**AFFIDAVIT OF CORRECTION**

This Affidavit of Correction is to correct the omission of the rear dimension on Lots 22 through 26, inclusive, Lot 29, Lot 30 and Lots 95 through 99, inclusive, FIVE FOUNTAINS, a subdivision, as surveyed, platted and recorded in the Douglas County, Nebraska Register of Deeds Office in Instrument # 2006106173 on September 14, 2006.

AFFIDAVIT OF CORRECTION

FOUNTAINS

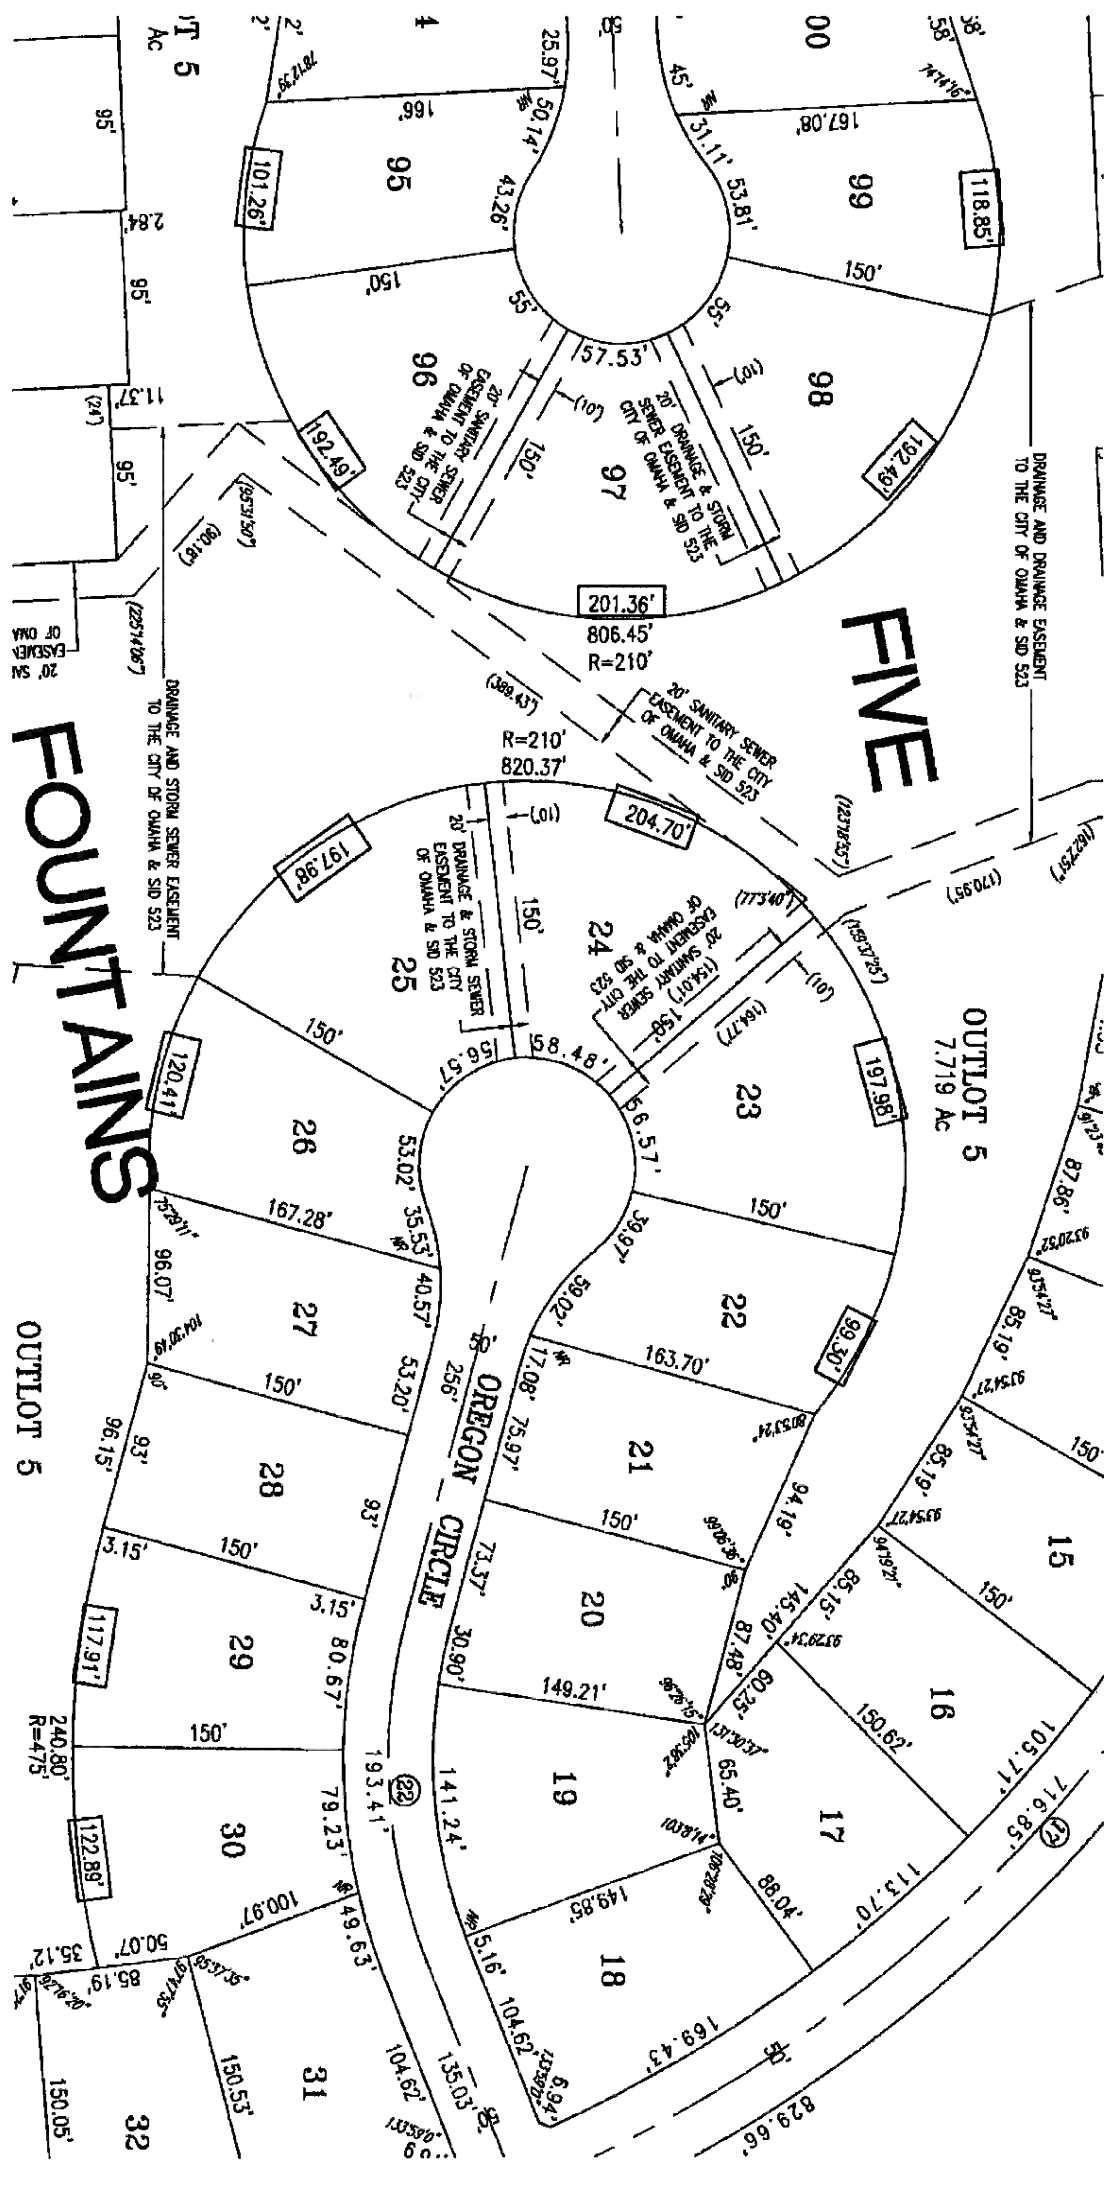
The correct arc dimension for each rear lot line along a radius of 210.00 feet is as follows:

- Lot 22 = 99.30'
- Lot 23 = 197.98'
- Lot 24 = 204.70'
- Lot 25 = 197.98'
- Lot 26 = 120.41'
- Lot 29 = 117.91'
- Lot 30 = 122.89'
- Lot 95 = 101.26'
- Lot 96 = 192.49'
- Lot 97 = 201.36'
- Lot 98 = 192.49'
- Lot 99 = 118.85'
